S E R V I C E N O T E

8593E Spectrum Analyzer

Counter-Lock Assembly modification to improve marker count stability under certain conditions.

Figure 1. A25 Counter-Lock Assembly

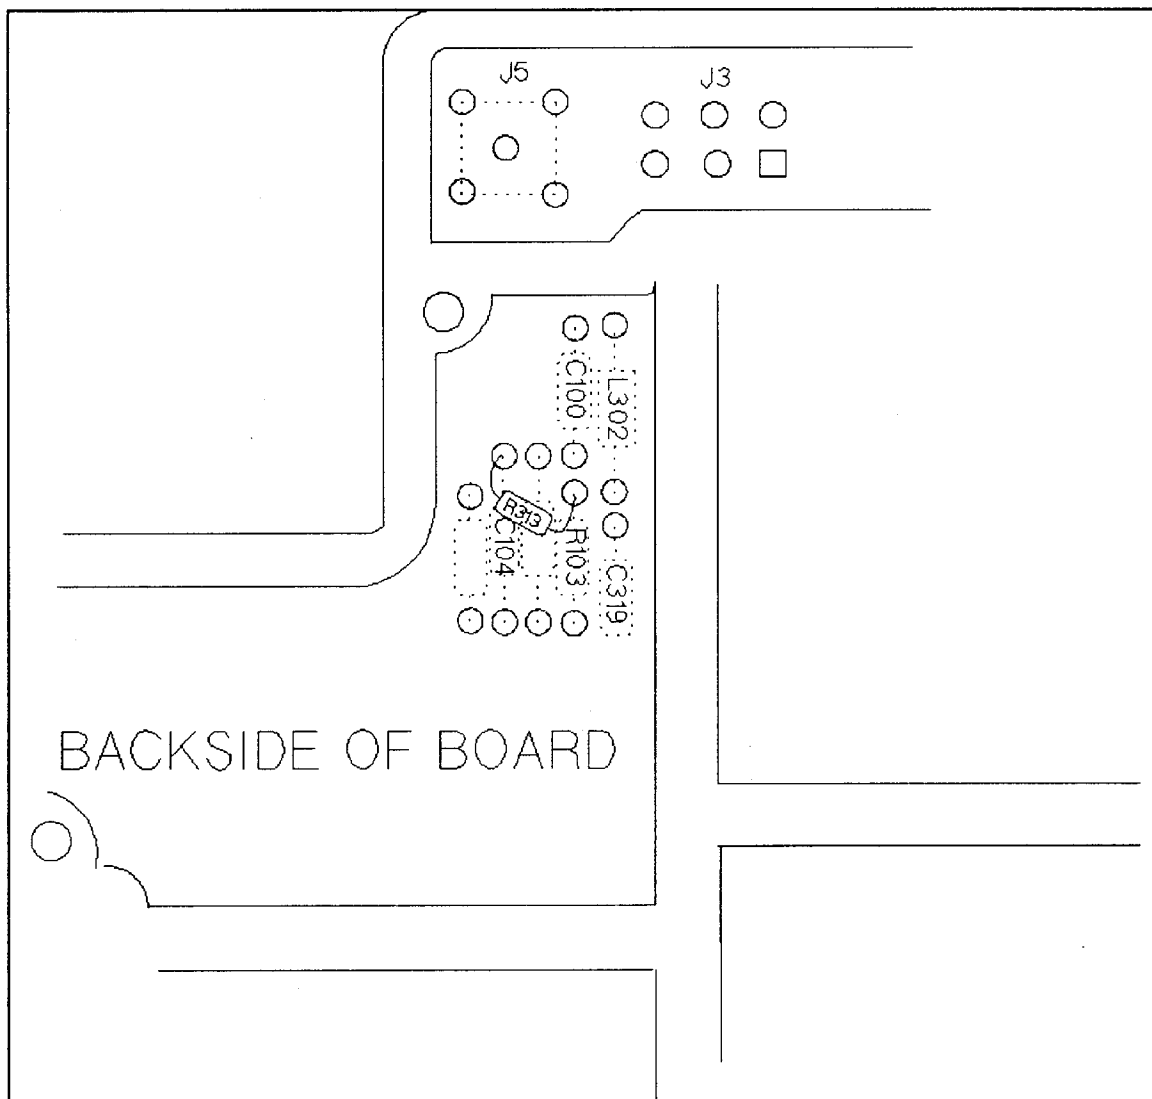
Instruments which have the A25 Counter Lock Assembly with P/N 08591-60053 or 08591-60061 may experience non-stable marker count readings. These non-stable counts are a problem while using marker count on AM modulated signals in wide Resolution BW's. When counting AM modulated signals (like the visual carrier of a TV signal) we have un-wanted modulation (15.7KHz sync rate) on the VIDEO_IF signal being combined with the COUNTER 21.4MHz input signal.

Add a high-pass filter circuit (corner freq of 1.4MHz) to the COUNT IF1(Block M) circuit which blocks the unwanted low frequency modulation signal and allows the 21.4MHz to pass through with very little loss.

1. Reference the A25 Counter-Lock Assembly Removal procedure. The procedure is located in the section of Service Guide labeled “Replacing Major Assemblies” on pages 7-41 and 7-42.
2. Remove the screw securing the two halves of the casting. Separate the casting halves and place the assembly bottom side up on the work surface.
3. Refer to Figure 1. for the location of R103 and remove R103. Install C321 in place of R103 but do not solder at this time. Install R313 as shown in Figure 1. One lead will share a hole with C321 (just installed). The other lead will share a hole with C104 as shown.
4. Apply the label (08591-60073) over the old board number.
5. Apply a label (08591-60073) onto the rear panel for future reference.
